October 5, 2022

**Re: Comment Letter for Proposed Redevelopment of 6950 SE Maker Street
Permit No. 2207-019**

EXHIBIT C

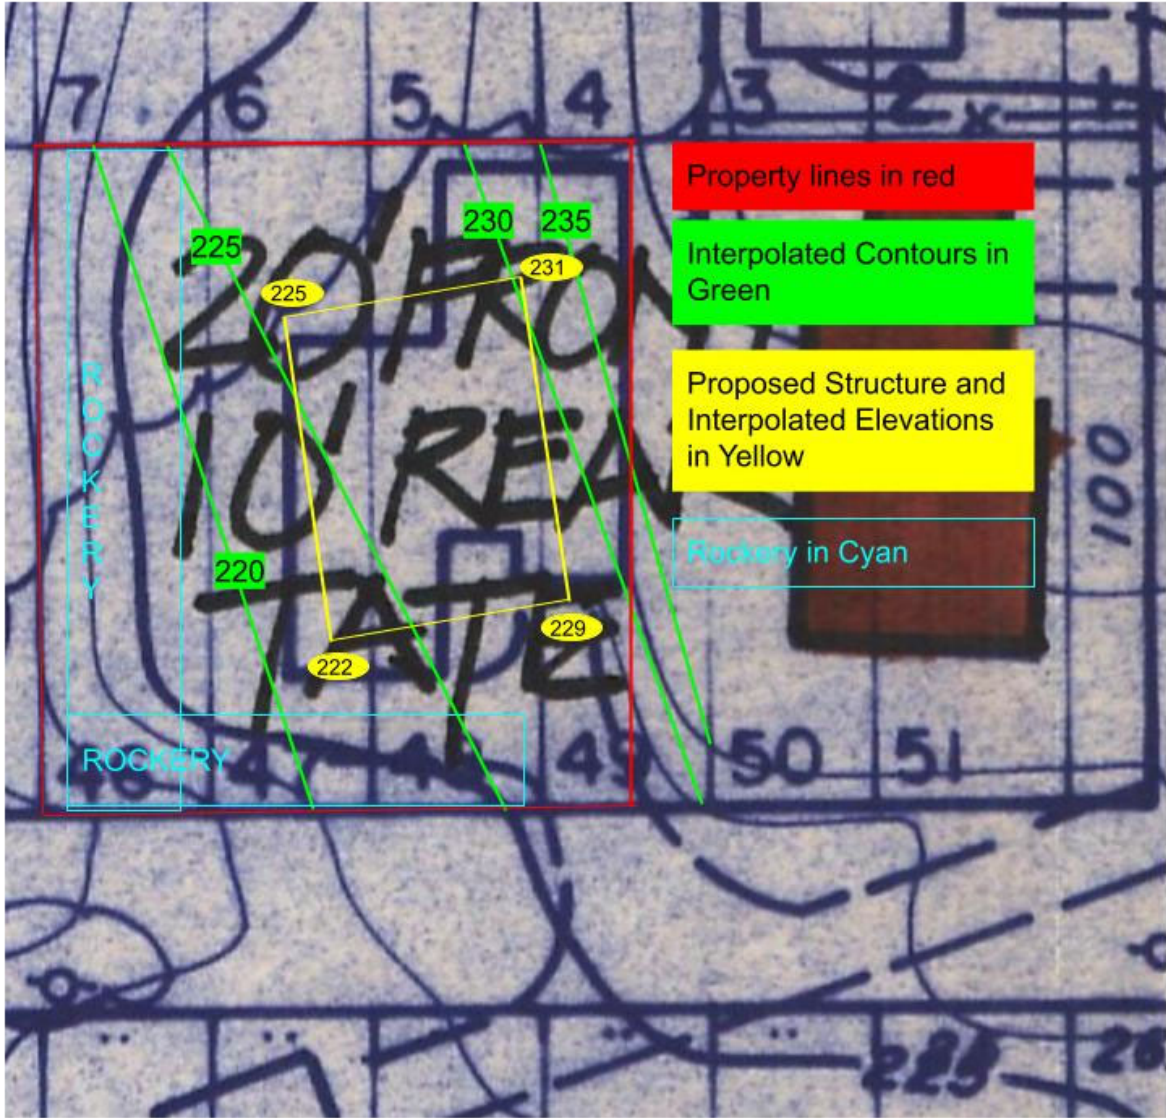
- Attached as **Exhibit C** is a larger scale survey ("1961 Survey") from no later than mid-1961. Based on Mr. Grove's discussions with Mercer Island Public Works and documents from the City of Mercer Island, Maker Street was a gravel road until at least 1963. As a result, this survey represents the original grade of SE Maker Street. This Survey shows the property roughly seven years after its initial development and aligns with the 7145 Survey.

EXHIBIT D

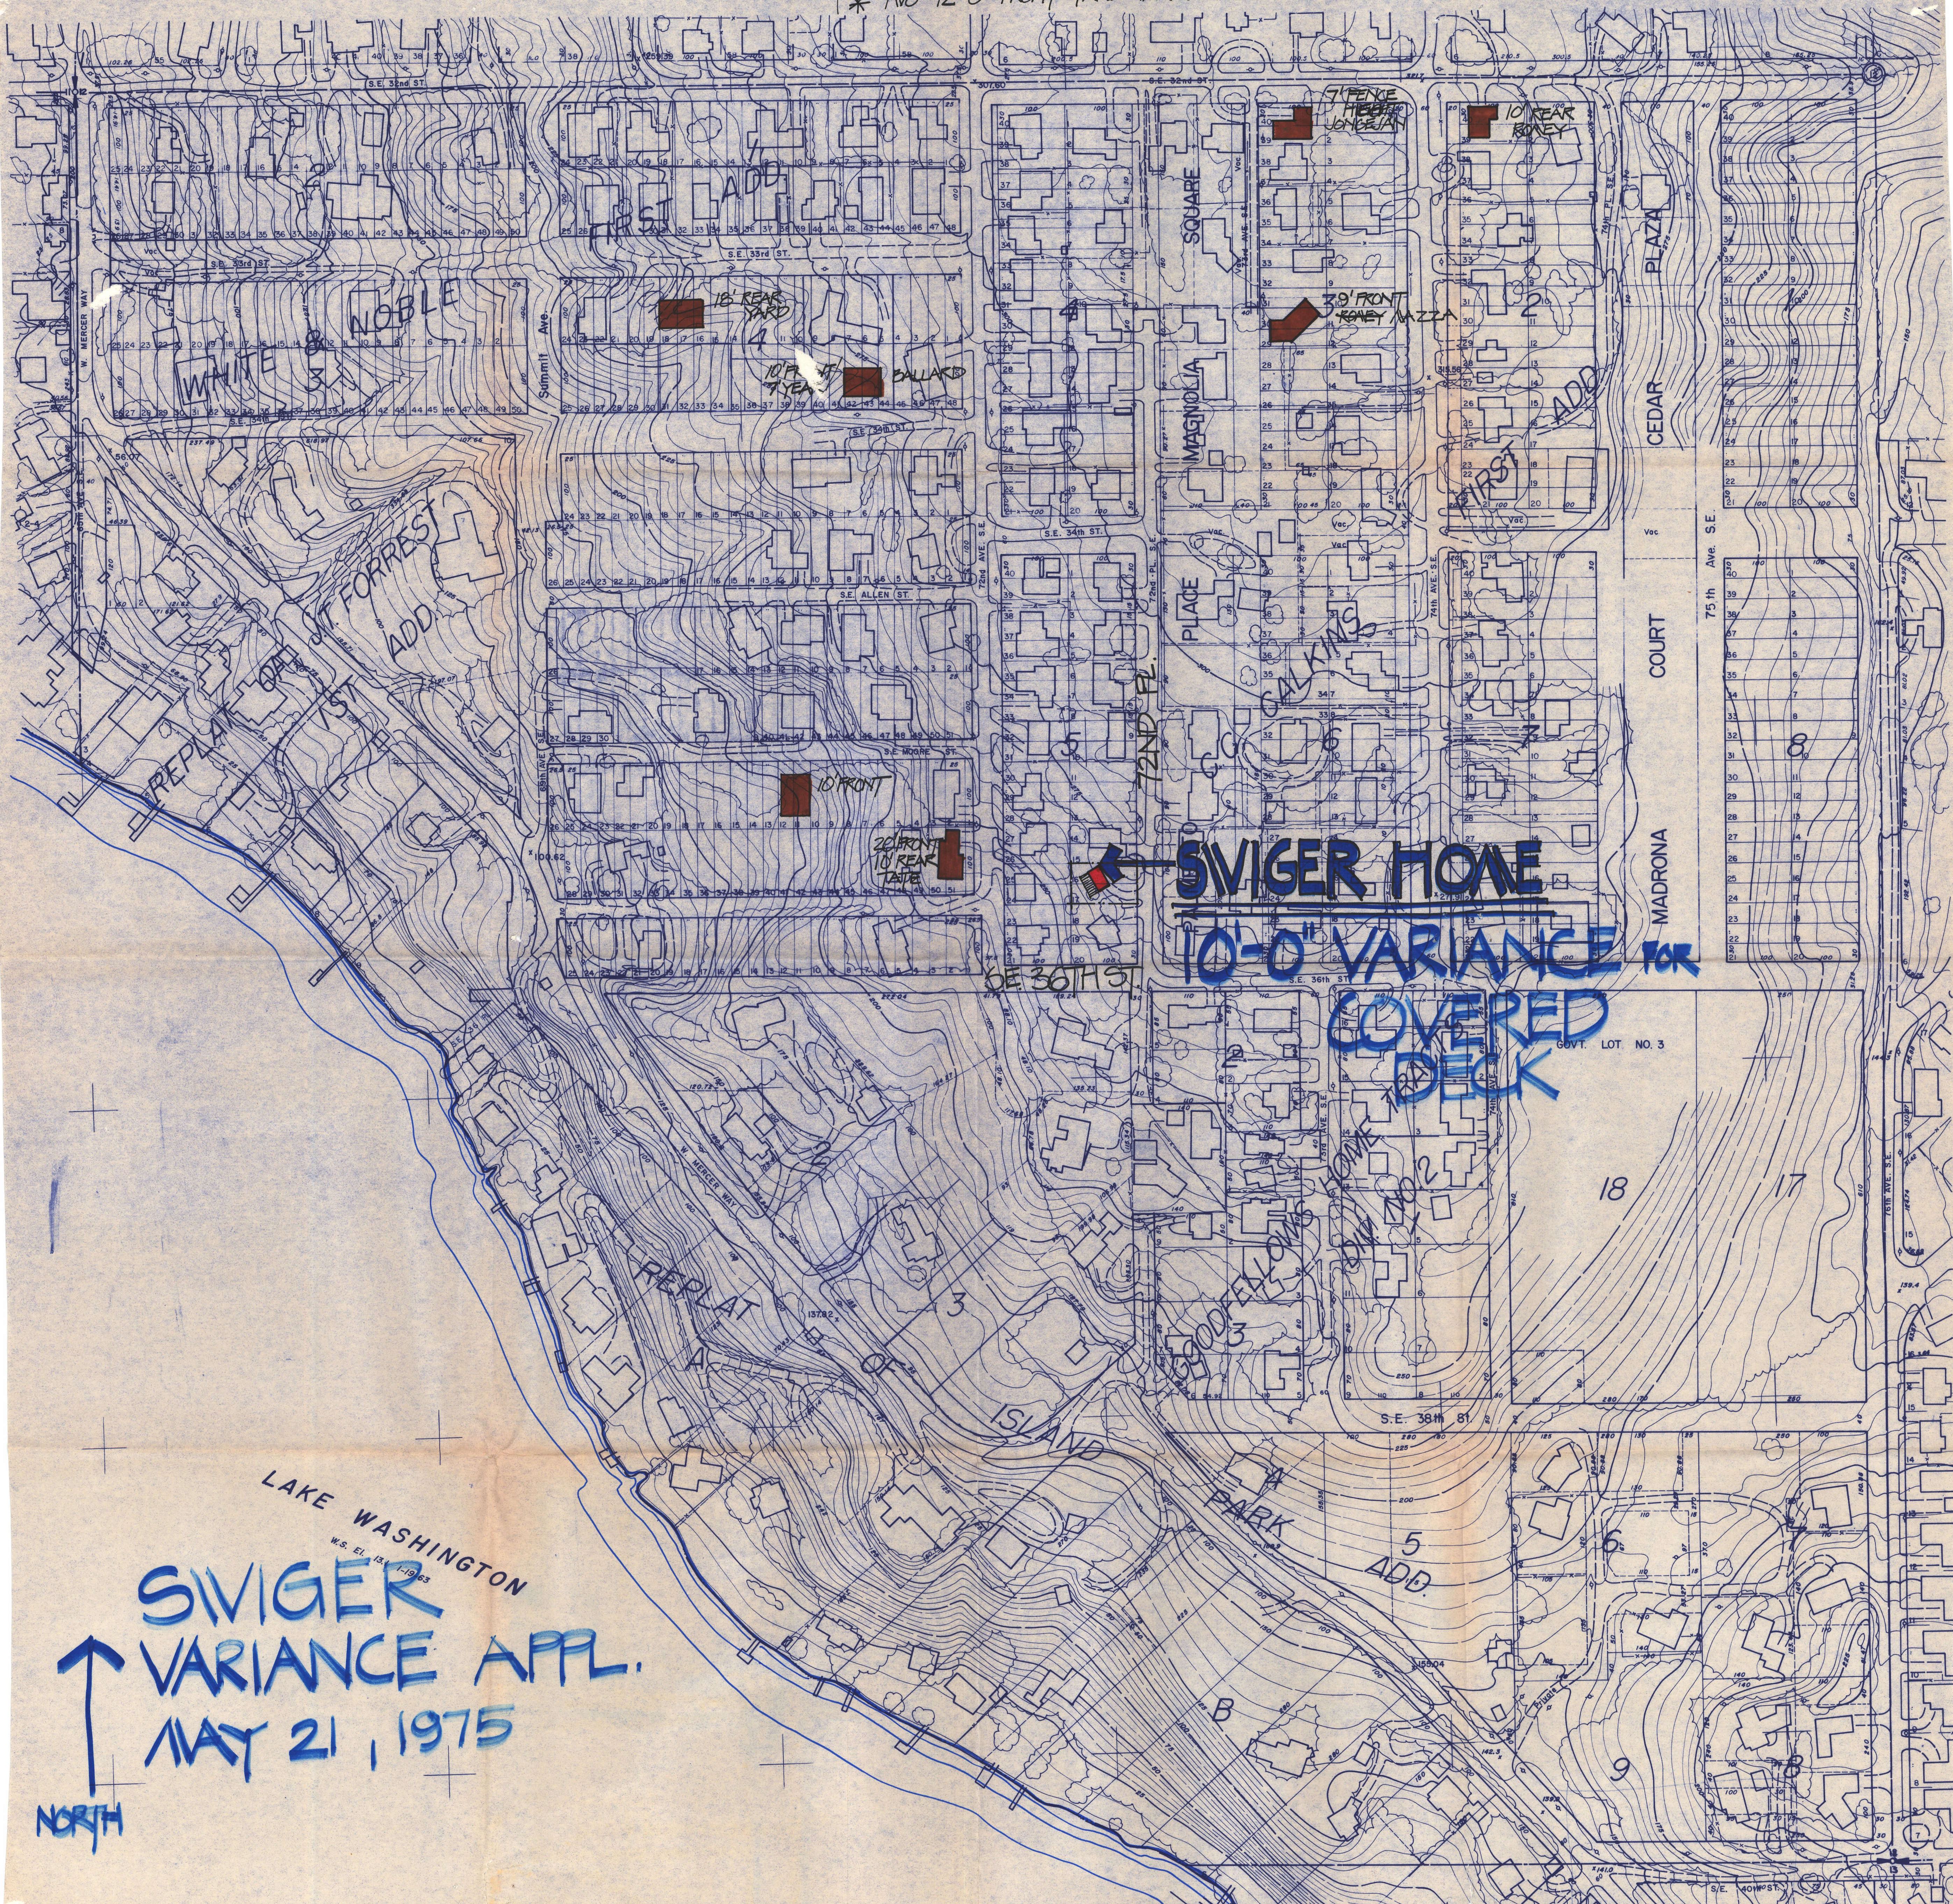
- Attached as **Exhibit D** is an overlay of this survey showing five-foot contours (shown in green) from the edges of the 6950 property and the proposed structure (shown in yellow).

The existing grade of the lot slopes down primarily from east to west in line with the slopes shown in the 7145 Survey (Exhibit A). The corner elevations below are the result of using the interpolated contours from Exhibit D and Exhibit E. The table below compares data from Exhibits A through E, and shows that the existing elevation of the proposed structure is closer to 226.6'–226.75'.
